SITE PLAN REVIEW AND APPEARANCE BOARD STAFF REPORT

318 SE 5th Avenue

Meeting	File No.	Application Type
March 22, 2023	2022-013-SPF-SPR-CLV	Class V Site Plan
Property Owner	Agent	
318 SE 5 th LLC	Jerrod Purser, WGI

Consideration of a Class V Site Plan, Landscape Plan, and Architectural Elevations for the construction of a four-story, mixed-use development located at the properties currently addressed as 302, 318, 338, and 346 SE 5th Avenue.

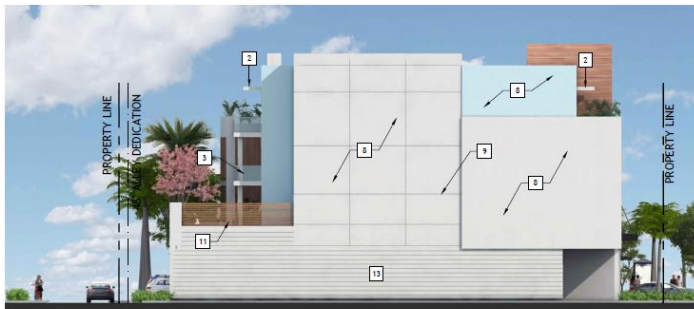
The proposed development is generally in conformity with good taste and good design as it incorporates many elements of the Masonry Modern architectural style outlined in the Delray Beach CBD Architectural Guidelines. The overall design and quality appearance is not anticipated to “materially depreciate” the adjacent neighborhood or other properties in the vicinity. In support of the Osceola Park Neighborhood Redevelopment Plan, the infill project is on the periphery of the neighborhood and strives to respect the single-family character, while providing additional housing options and business opportunities within walking distance of the neighborhood.

While the development complies with the minimum requirements to mitigate impacts on the adjacent neighborhood (additional upper-story setbacks, rooftop terrace screening, landscaping), the agglomeration of the lots allows for the construction of a single building. There are no specific design elements that are not in keeping with the architectural style or the intent of the Criteria for Board Action.

The Board can consider if additional measures should be taken to further protect the residential neighborhood from the larger scale and massing of the building, or if additional architectural detailing would assist in further enhancing the Masonry Modern style.

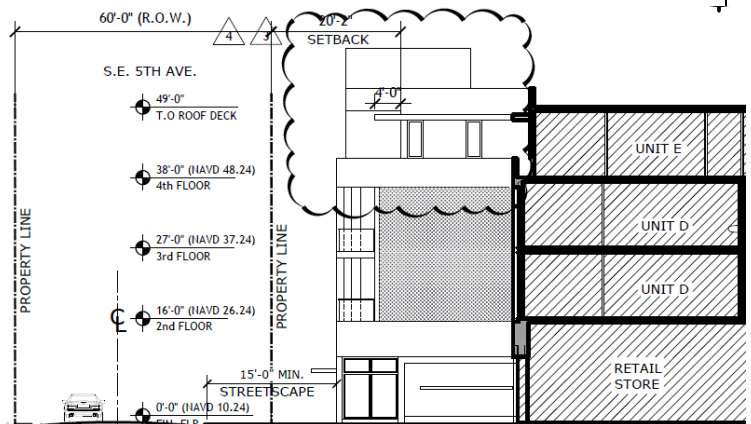
Note that special consideration should be given as to whether the pedestrian passageway meets the intent of the LDR. Specifically, **LDR Section 4.4.13(D)(2)(a)(6)** states that a building with more than 250 feet of street frontage shall provide a pedestrian/bicycle passageway of at least 10 feet wide connecting rear alleys and/or parking to the public sidewalk. The development proposes a 10-foot-wide pedestrian passageway on the north side of the building, connecting the civic open space to the parking in the rear.
